### APPEAL SUMMARY

**Appeal ID:** 27746

**Project Address:** 1705 SW 11th Ave

**Plan Submitted Option:** pdf [File 1] [File 2] [File 3] [File 4] **Proposed use:** Unmanned Rooftop Telecom Facility

EXISTING & PROPOSED  
BUILDING ELEVATIONS

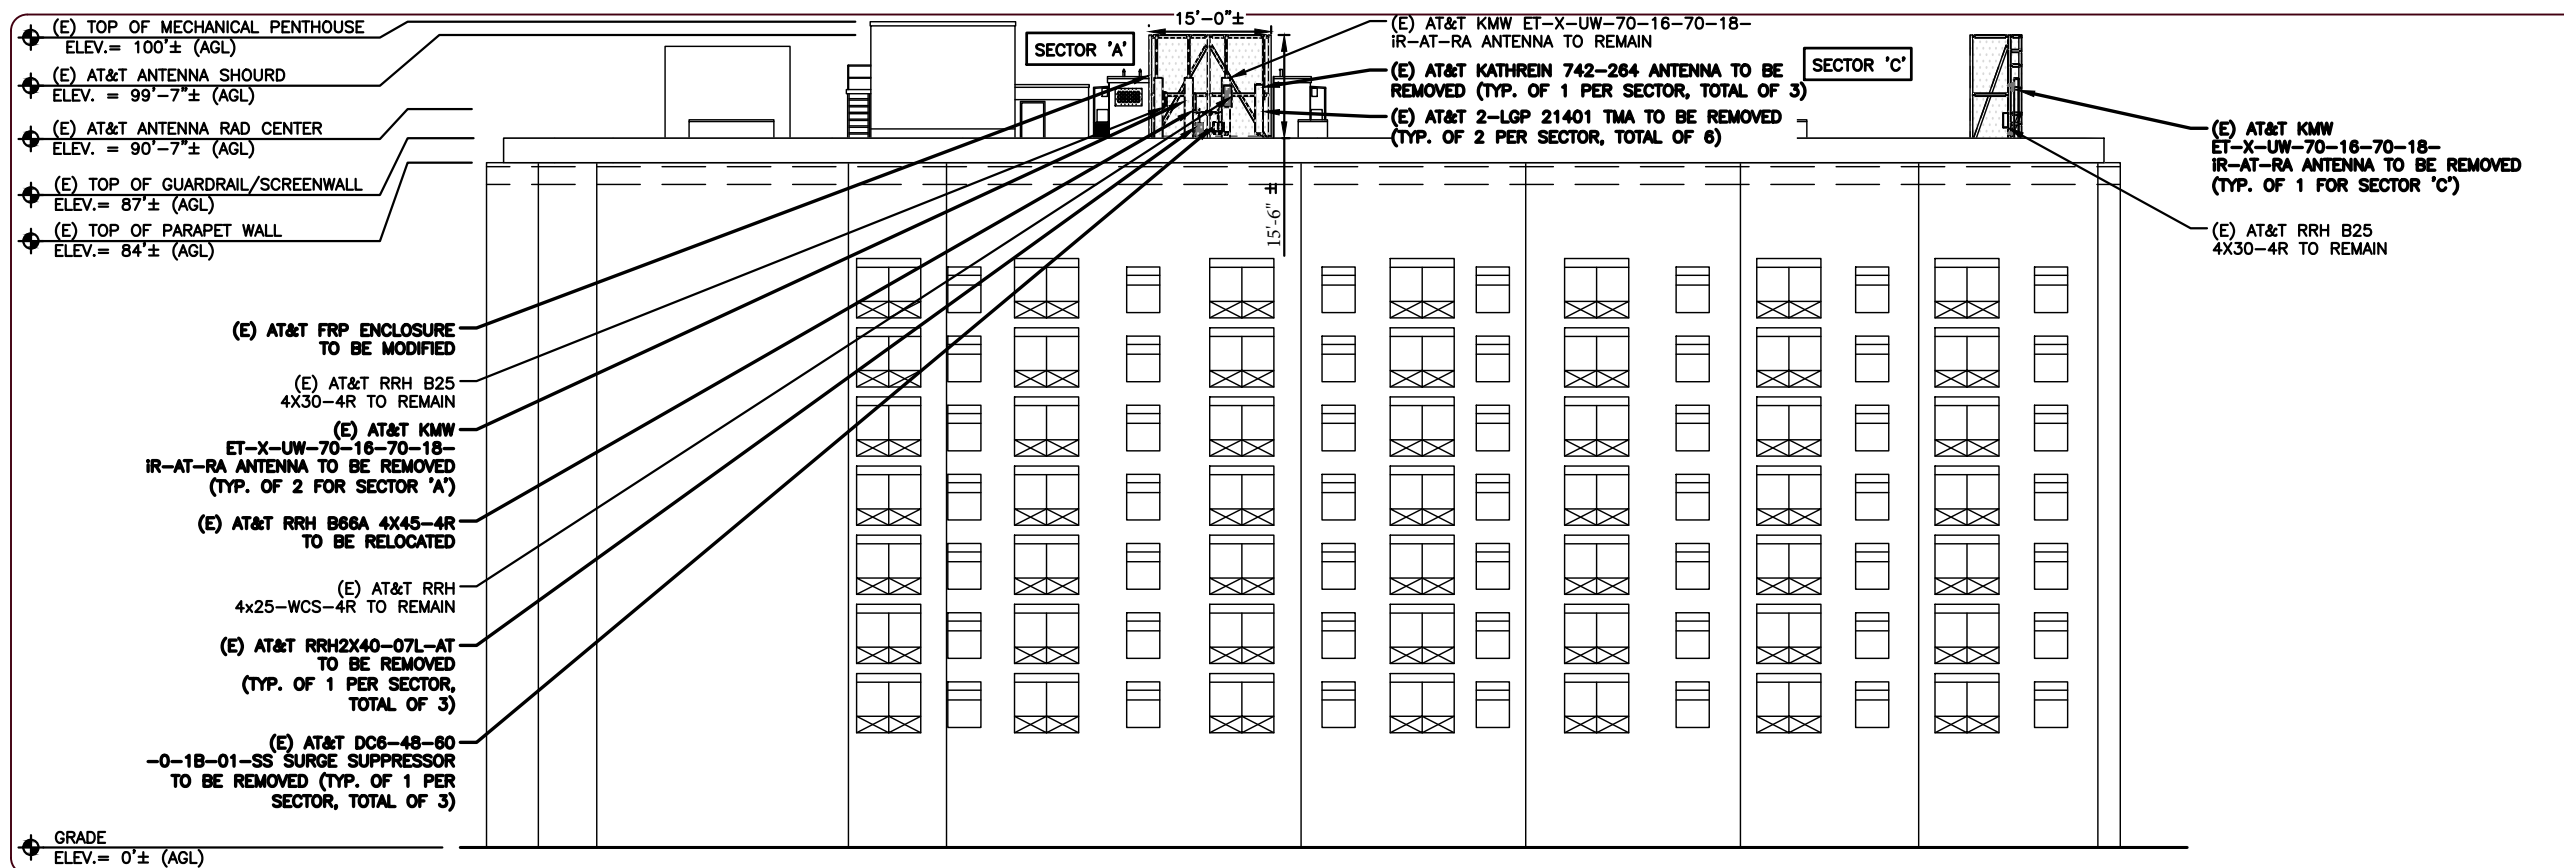
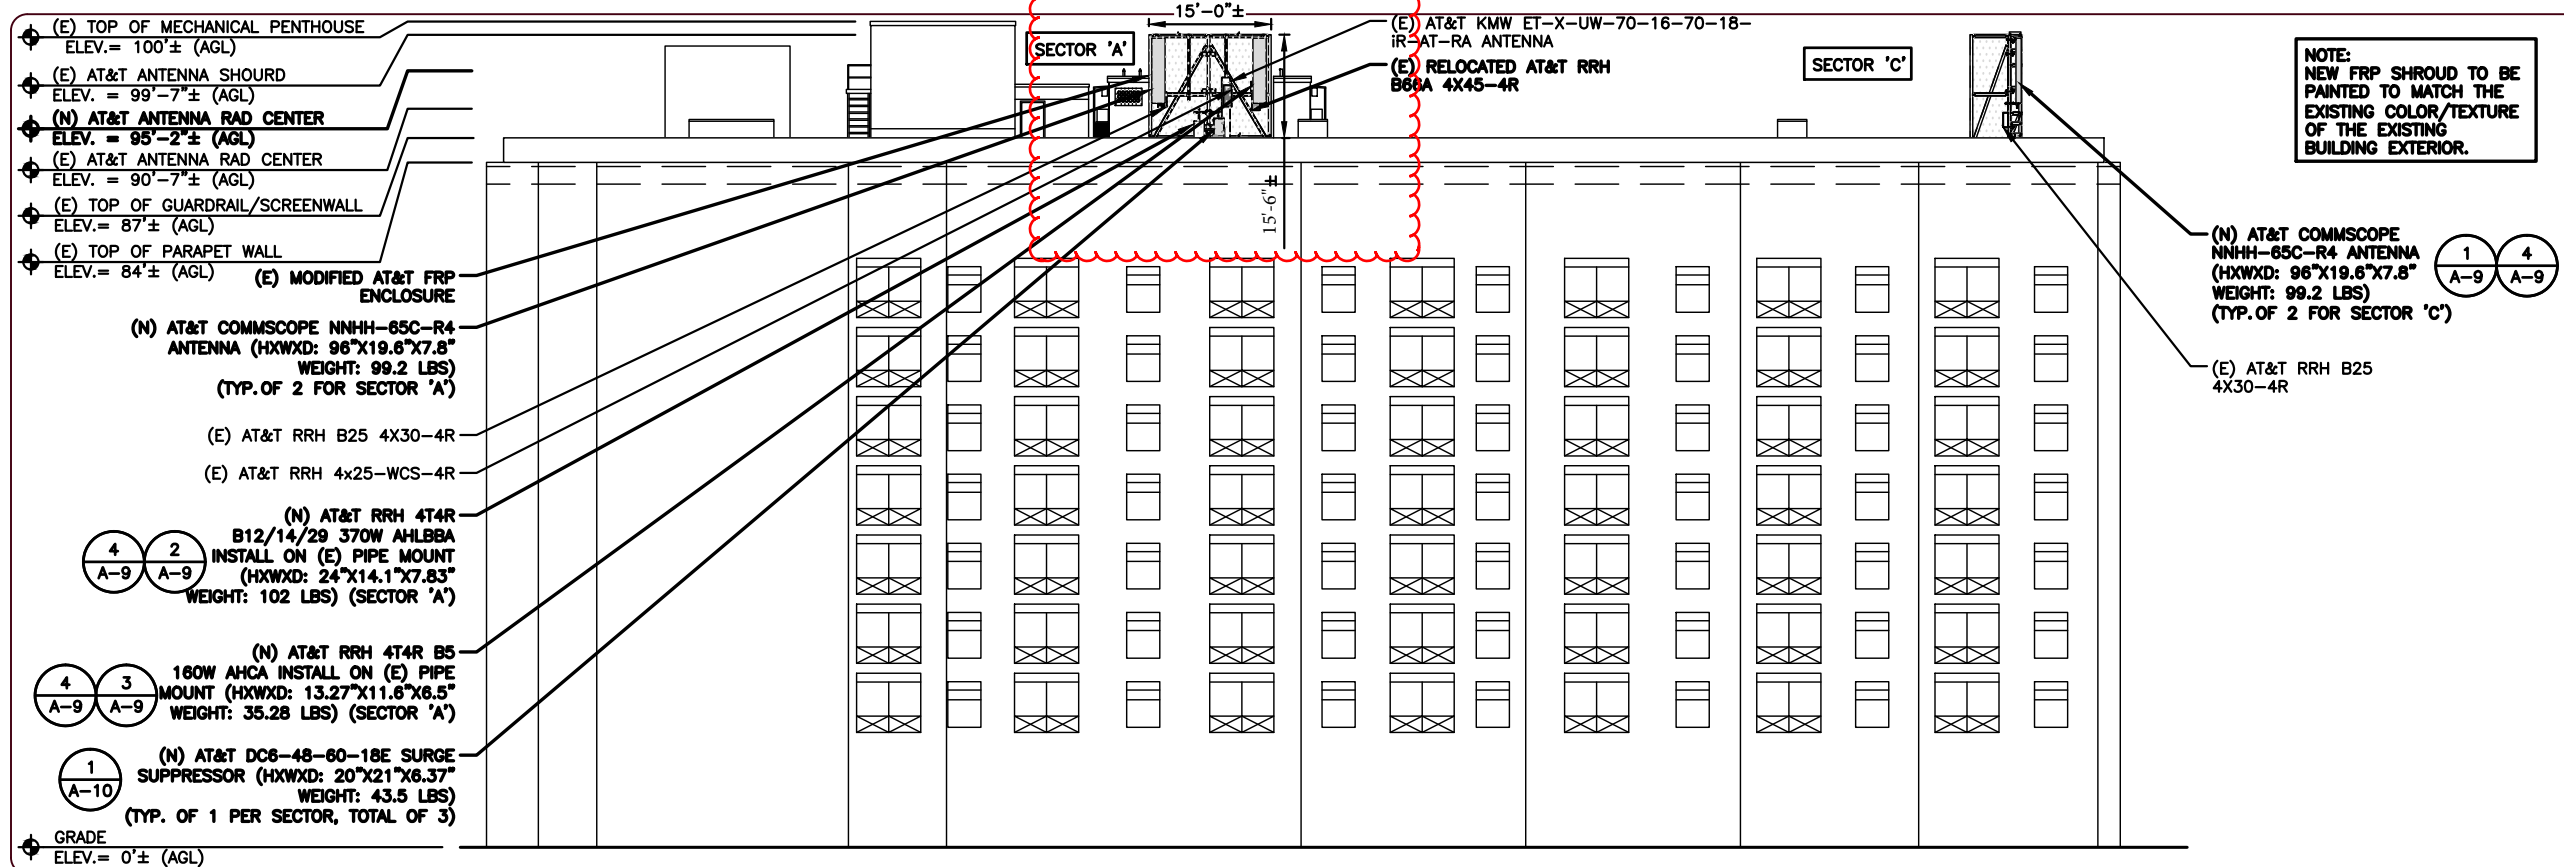
The intent of this appeal is to allow the FRP screens to stay at the existing 15'-6" above the roof.

As detailed in the LA-RR dated February 15, 2021, there is a maximum allowable height of 18 feet above the roof level. The overall height being proposed is 15'6", which is below this limit. Additionally, the individual rooftop screening panel area in any one plane is less than 250 square feet, and the total maximum aggregate area of all panels shall not exceed the larger of 3 square feet per foot of building frontage or 5 percent of the area of the roof.

**Increase in maximum allowable height of FRP screens from 10 feet to 15 feet 6 inches above the roof of a Type IIA building: Granted provided all FRP products used are Stealthskin Enclosure System from Raycap as approved in Research Report: RR 25400 issued February 15, 2021 (Exhibit C) and that a copy of the report is included with the project documents submitted for the building permit.**
